# HISTORIC AND DESIGN REVIEW COMMISSION

**HDRC CASE NO:** 2022-056  
**ADDRESS:** 555 S ALAMO ST  
**LEGAL DESCRIPTION:** NCB 901 BLK LOT 44, 45 & 46  
**ZONING:** D, H, RIO-3  
**CITY COUNCIL DIST.:** 1  
**DISTRICT:** La Villita Historic District  
**APPLICANT:** James McKnight/Brown & Ortiz, PC  
**OWNER:** Eric Stone/AUTO HOTEL LLC  
**TYPE OF WORK:** Construction of a fitness center, construction of accessory structures, site modifications,  
**APPLICATION RECEIVED:** January 14, 2022  
**60-DAY REVIEW:** Not applicable due to City Council Emergency Orders  
**CASE MANAGER:** Edward Hall

**Historic and Design Review Commission**  
***Design Review Committee Report***

08 POOL BAR - SOUTH ELEVATION  
3/8" = 1'-0"

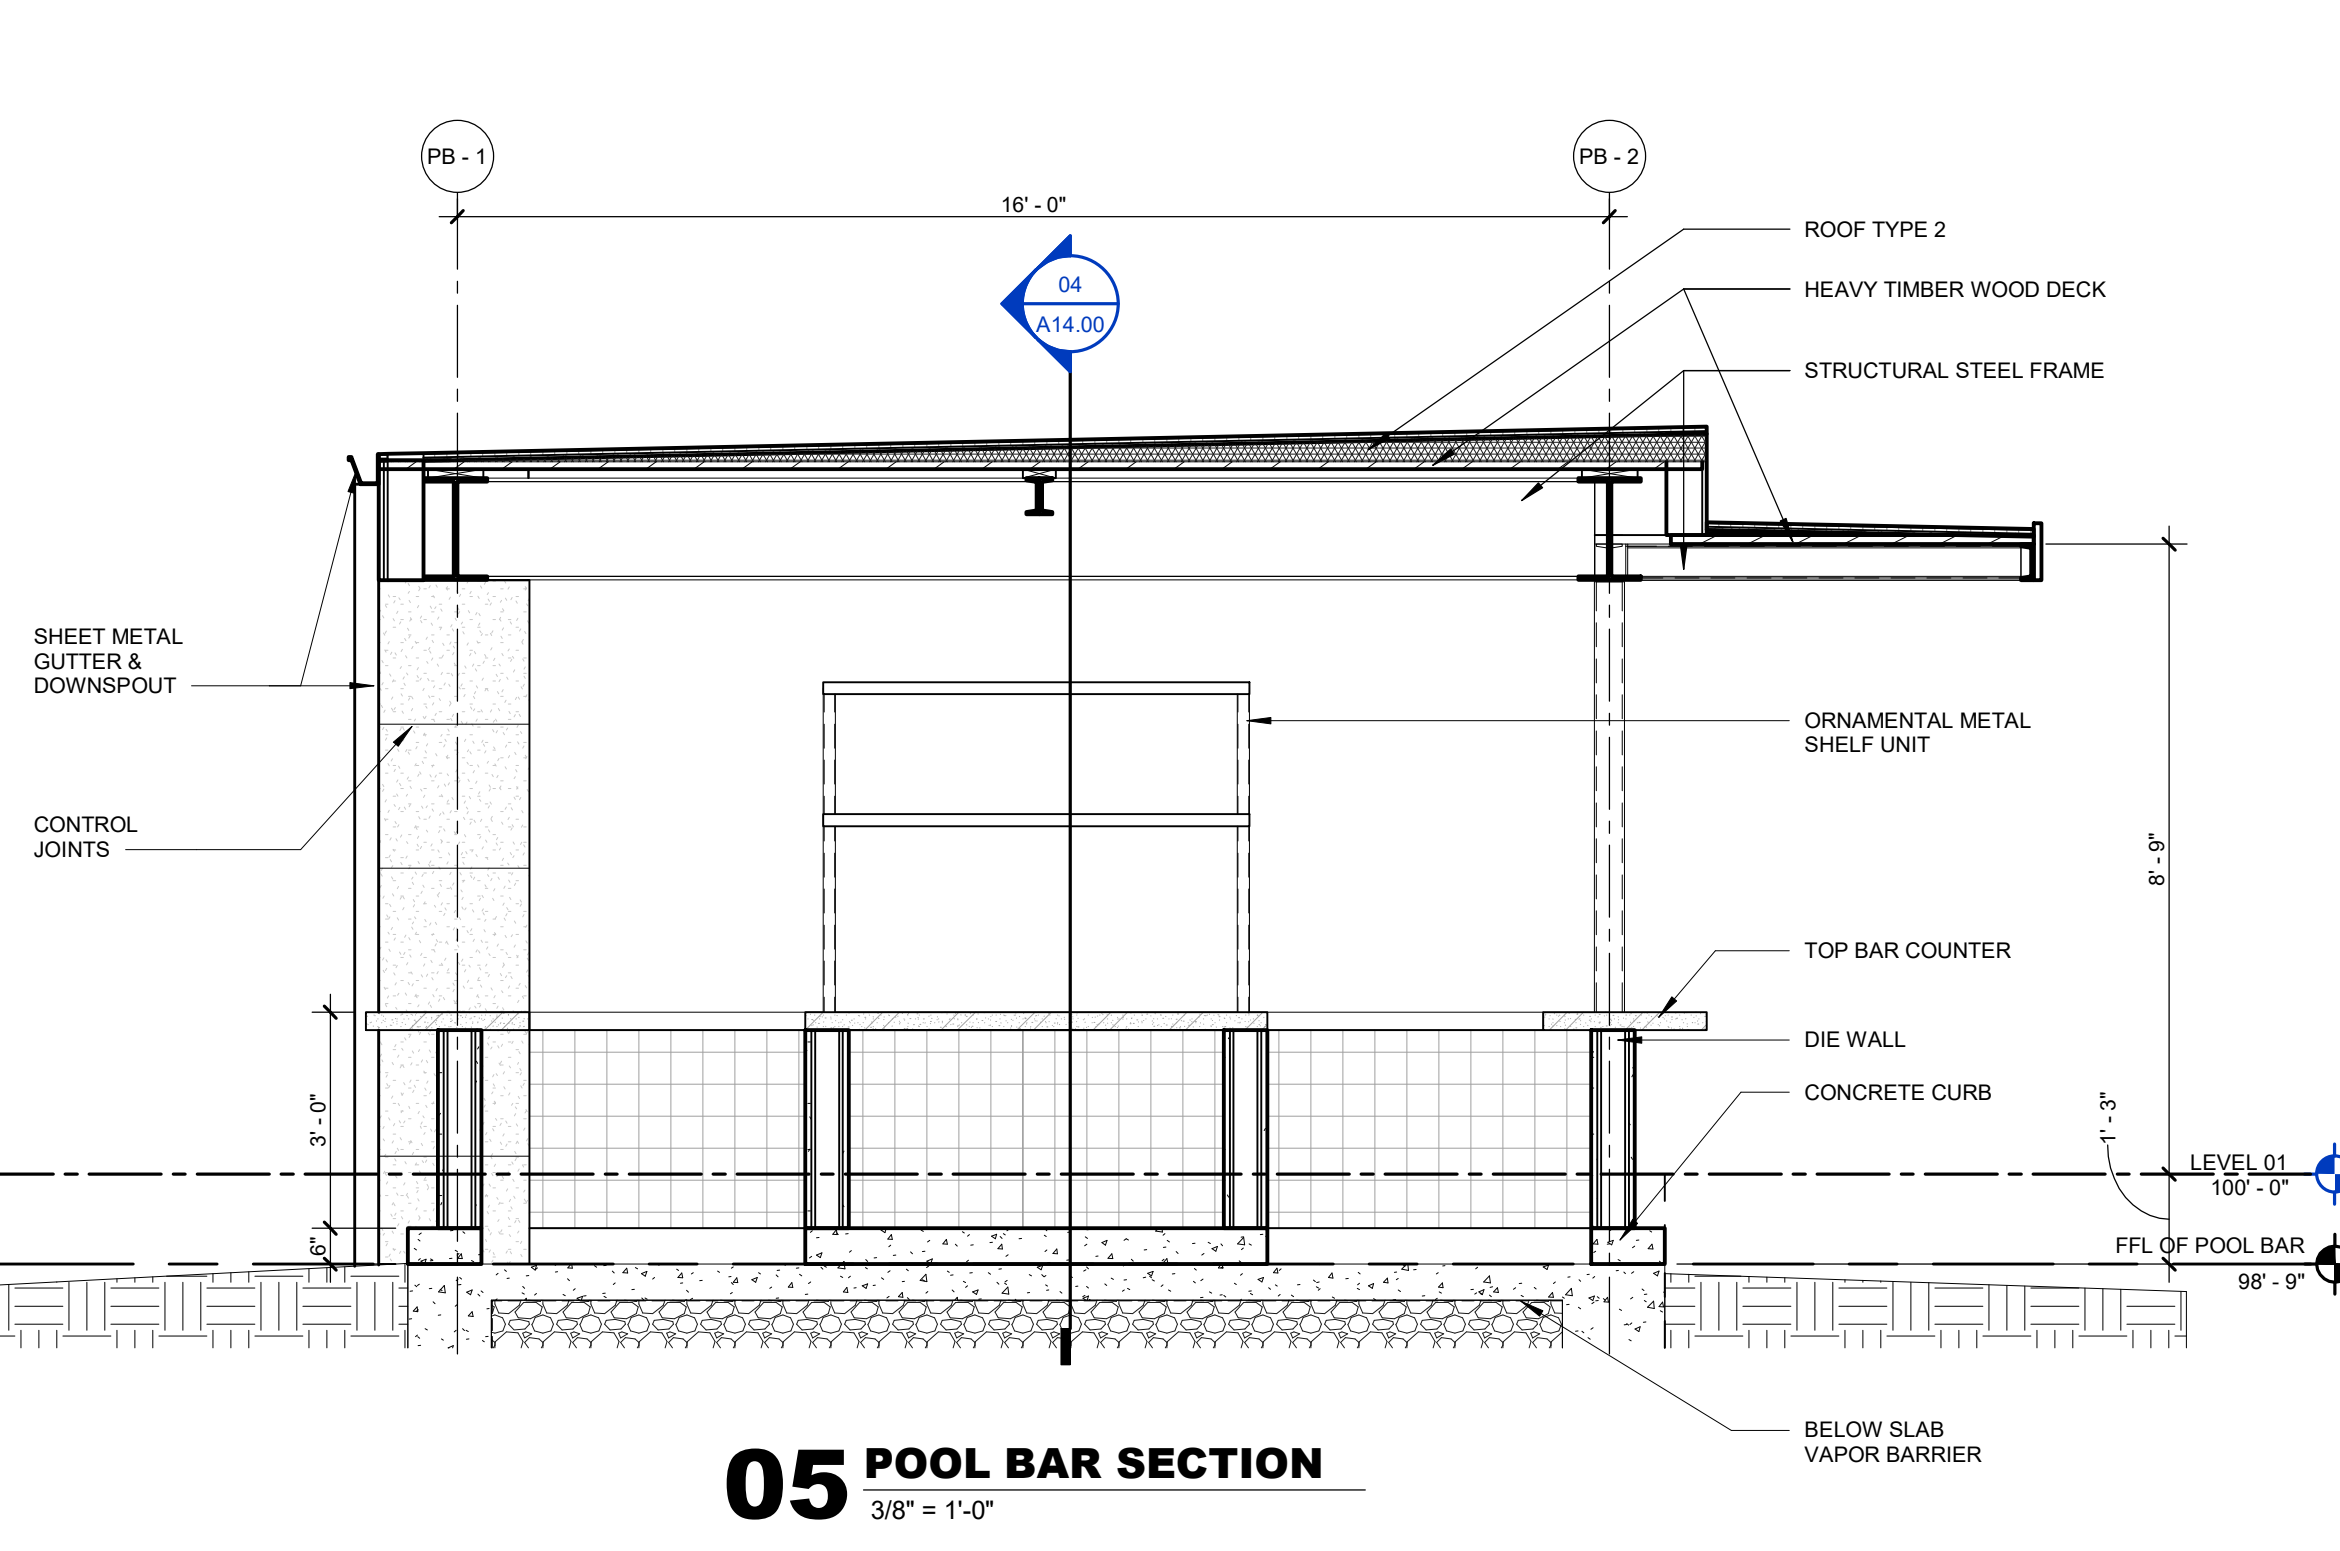
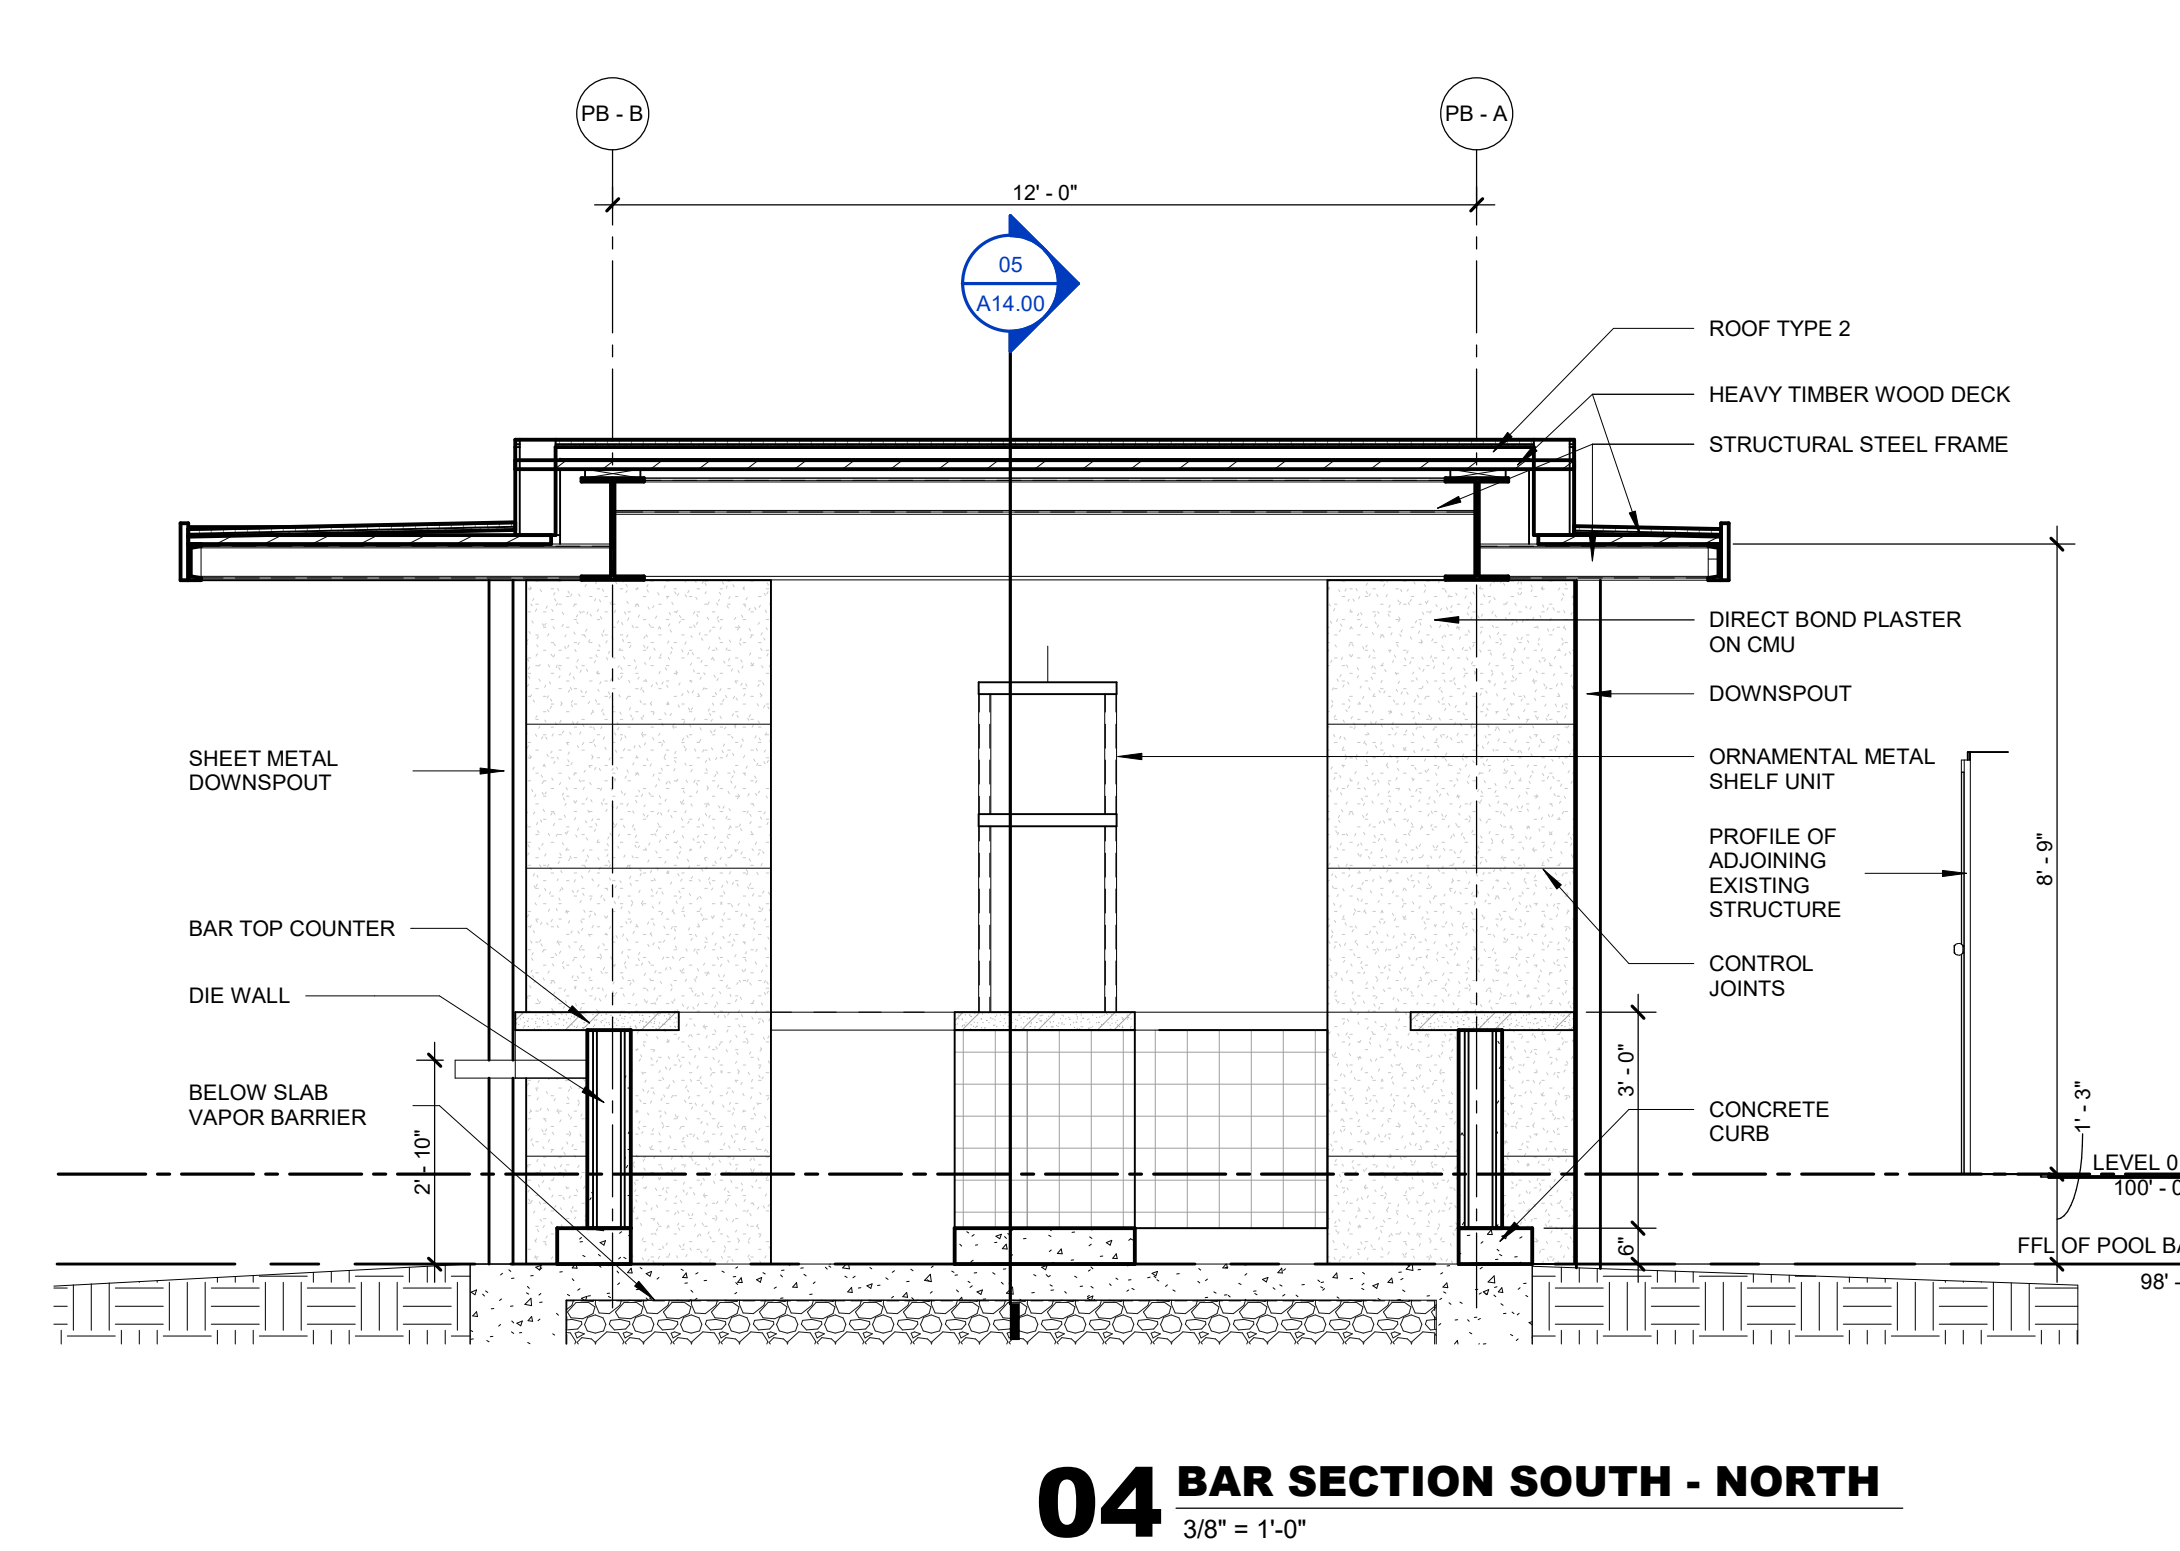
GV: Concerned about the proximity of the roof structure of the pool pavilion to the adjacent historic structure. Does not find the roof plane to be the correct solution.

JF: Study the roof form and the relationship between the north side of the roof in relationship to the historic building – not as much overhang will be needed on the north side.
